# NFPA 805 OBSERVATION VISIT TRIP REPORT

**Date:** March 27-30, 2006

**Subject:** Risk-Informed, Performance-Based Fire Protection Transition Pilot-Plant Observation Visit - Harris Nuclear Plant and Oconee Nuclear Station

### Issue Summary Sheet No. 1

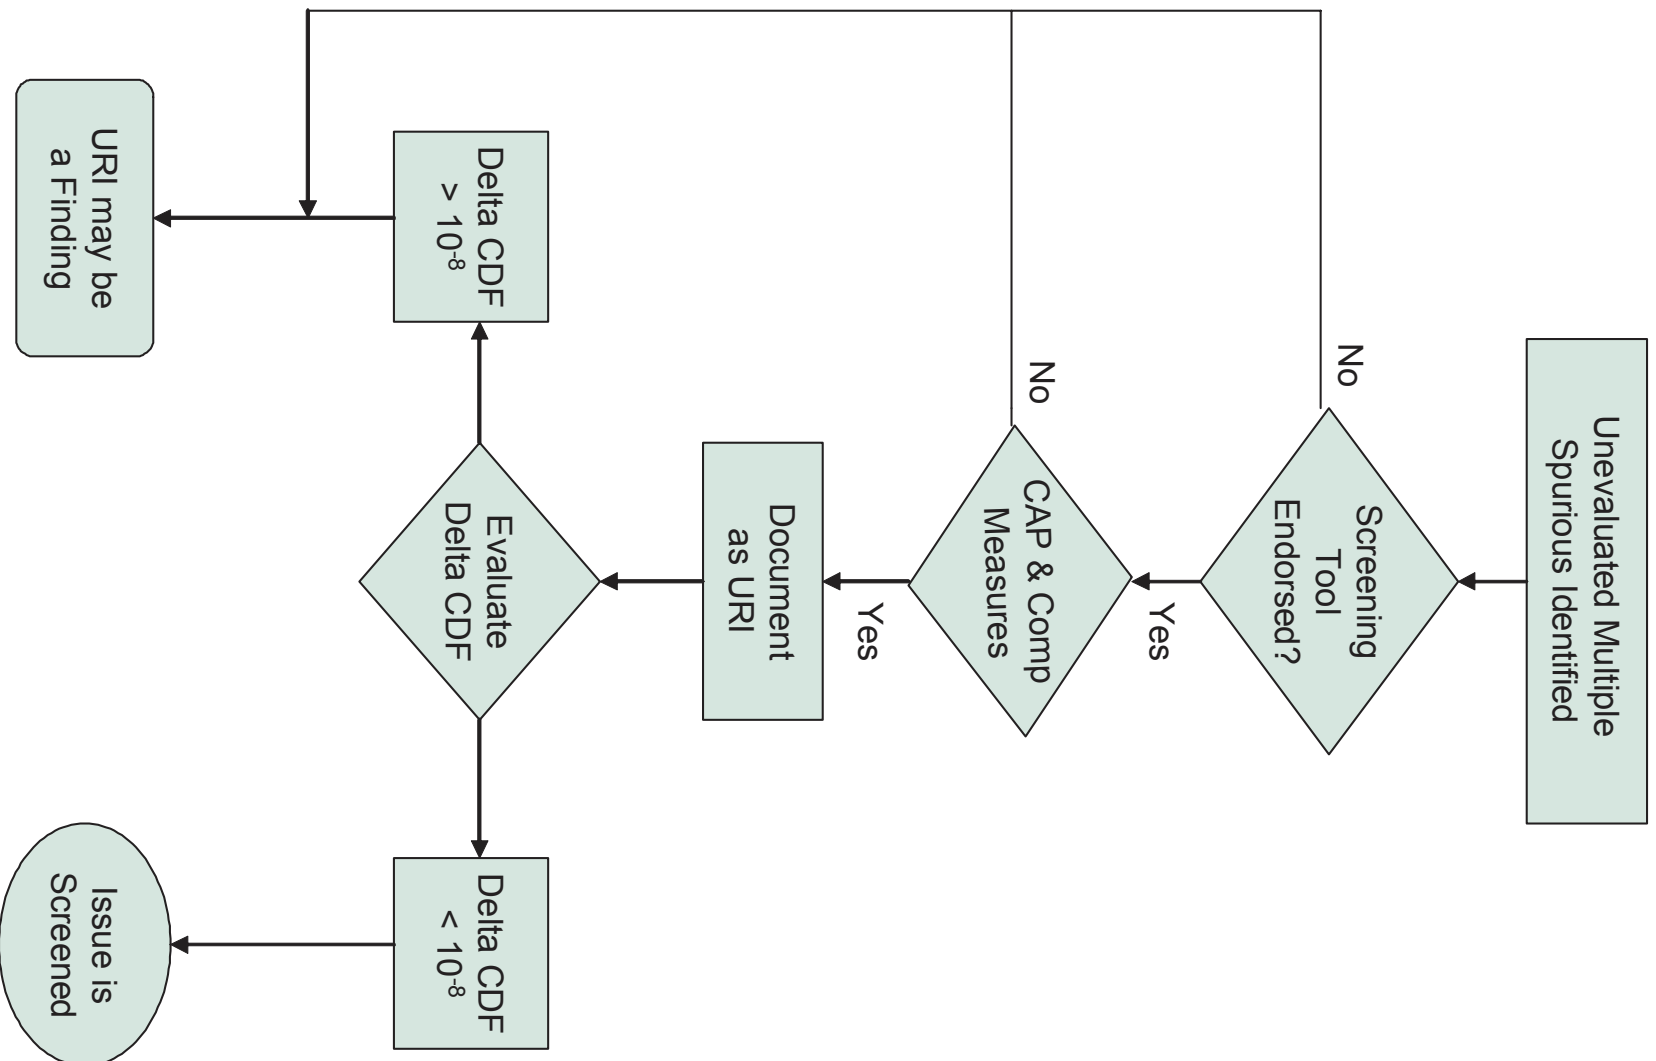
The NRC staff presented a flowchart during the March 2006 pilot plant observation meeting that illustrated how new multiple spurious operations (identified during inspections) would be treated (See flow chart below). In addition to the flowchart, the following information was also conveyed during the meeting:

- If the circuit issue identified by the inspector and its related contributors that were also omitted are “greater than Green” OR “constitute a violation of defense-in-depth” or “safety margins,” in spite of using an appropriate screening tool, that would constitute a minor violation. If the inspector determines that the licensee’s screening tool is flawed, that would constitute a violation. Here “related contributors” are those that are associated via the same root cause, fire scenario, or fire area.

- If the circuit issue identified by the inspector and its related contributors that were also omitted are “less than Green” AND “do not constitute a violation of defense-in-depth” or “safety margins” AND the licensee has used an appropriate screening tool, no further action is warranted. However, if the inspector determines that the licensee’s screening tool is flawed, that would constitute a minor violation.

The process outlined in the flowchart documents (new) unevaluated multiple spurious operations as unresolved items (URIs) and proposes a risk threshold below which the multiple spurious operation is screened (a potential threshold for such “treatment” of 1E-08/yr delta-CDF [1E-09/yr delta LERF] was offered for discussion). Industry raised the concern that documenting all

multiple spurious operations as URIs pending evaluation will create a significant cost and resource impact because all URIs must be formally dispositioned and even those classified as minor can require 1000 hours. Industry's preference would be to not treat the new multiple spurious as a URI, but to disposition the issue within the fire probabilistic safety assessment (PSA) process. Consensus was to review the minor questions in Inspection Manual Chapter (IMC) 0612, and suggest development of new questions if necessary such that multiple spurious operations below a certain threshold could be relegated to minor and treated accordingly.

**Resolution Action(s)/Action Party:** OPEN. Industry and pilot-plant participants agreed to review the flowchart, IMC 0612 questions, screening thresholds and provide feedback to the NRC at the next observation meeting. The industry may also submit an FAQ on the issue.
